Access Compliance Report

Public Rights-of-Way

(Curb Ramps)

Intersection ID: 30075	Main Street: SOUTHWIND_DR	Cross Street: WOODLANDS_POINTE_DR	Location: SE
ADA ID: 9FBEE649AC9C	Ramp Type: PerpDiag	Initial Pass/Fail: Fail	Overall Compliance: No
Codes/Mitigation Info/Possible Solution		Field Measurements/Component Compliance	
Severity Score: 26.25

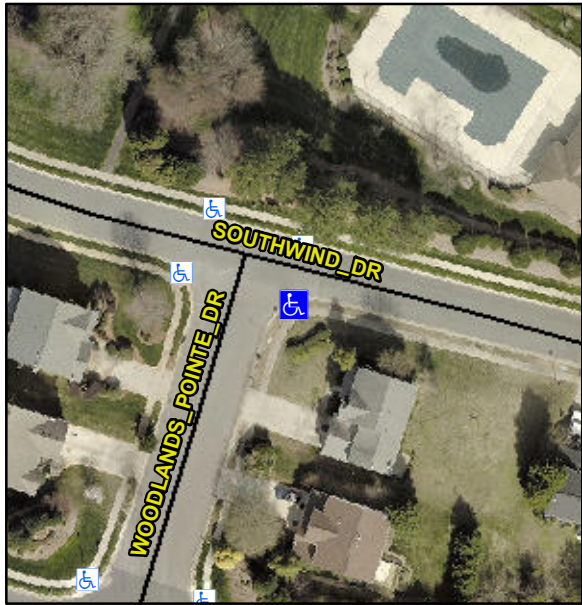
Not Found, R304.2.2, R304.5.3

Compliance	Description	Data	Compliance	Description	Data
N/A	Ramp Length (in)	59.0	No	Ramp Slope (%)	12.2
Yes	Ramp Width (in)	48.0	No	Ramp XSlope (%)	3.2
N/A	Flare Type LT	N/A	N/A	Flare Type RT	N/A
N/A	Flare Slope LT (%)	N/A	N/A	Flare Slope RT (%)	N/A
N/A	Flare Traversable LT?	N/A	N/A	Flare Traversable RT?	N/A
N/A	Landing Length (in)	N/A	N/A	DWS Provided?	N/A
N/A	Landing Width (in)	N/A	N/A	DWS Contrast?	N/A
N/A	Landing Slope (%)	N/A	N/A	DWS Length (in)	N/A
N/A	Landing X Slope (%)	N/A	N/A	DWS Full Width?	N/A
N/A	Landing Curb? (Y/N)	N/A	N/A	DWS Offset (in)	N/A
N/A	Shared Landing?	N/A			
N/A	Gutter Ponding?	N/A	N/A	Gutter Slope (%)	N/A
N/A	Gutter Lip Ht (in)	N/A	N/A	Gutter X Slope (%)	N/A
N/A	Painted X Walk1?	No	N/A	Painted X Walk2?	No
	X Walk 1 Direction	To NE		X Walk 2 Direction	To NW
N/A	X Walk 1 Width (in)	N/A	N/A	X Walk 2 Width (in)	N/A
	X Walk 1 Slope (%)	4.1		X Walk 2 Slope (%)	1.6
	X Walk 1 X Slope (%)	1.0		X Walk 2 X Slope (%)	2.2

Remove & Replace Curb Ramp With Two New Directional Ramps or Equivalent.
